Rezoning Transportation Analysis

Petition Number: 2022-210

Revision Log:

General Review Information

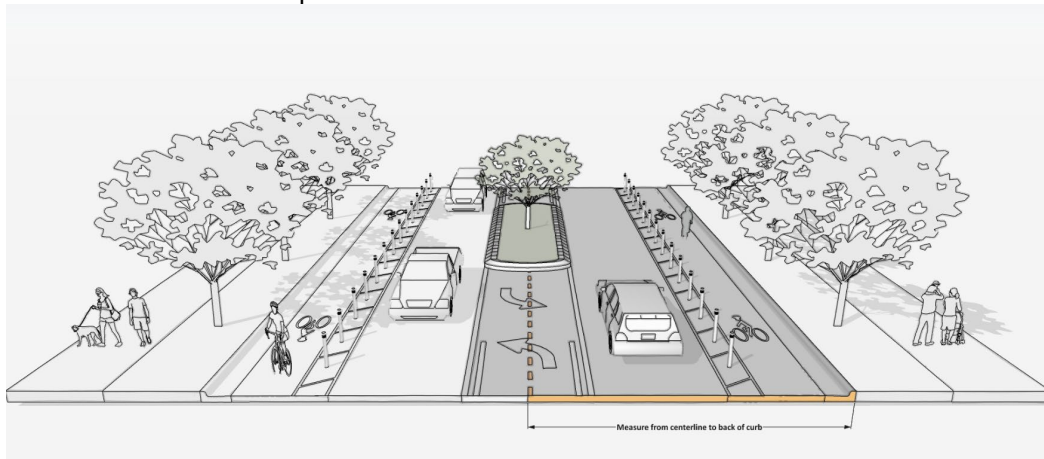
- a. **South Tryon Street:** Location of curb and gutter to be moved a minimum of 42.5 feet from roadway centerline to accommodate the Charlotte Streets Map with a roadway typical section of a 4+ Avenue with Buffered/Separated Bike Lanes and On-Street-Parking.

- b. **Clanton Road:** Location of curb and gutter to be moved a minimum of 27 feet from roadway centerline to accommodate the Charlotte Streets Map with a roadway typical section of a 2+ Avenue with Buffered/Separated Bike Lanes.

NOTE: Additional distance from center line to back of curb may be required in locations where a median and turn lanes are required. Final curblines to be reviewed by CDOT once TIS is approved.

Label and dimension the curb and gutter from the centerline for each road on the site plan.

Clarifying comment 6.21.23: Label and dimension the curb and gutter from the centerline for Clanton Road and South Tryon Street.
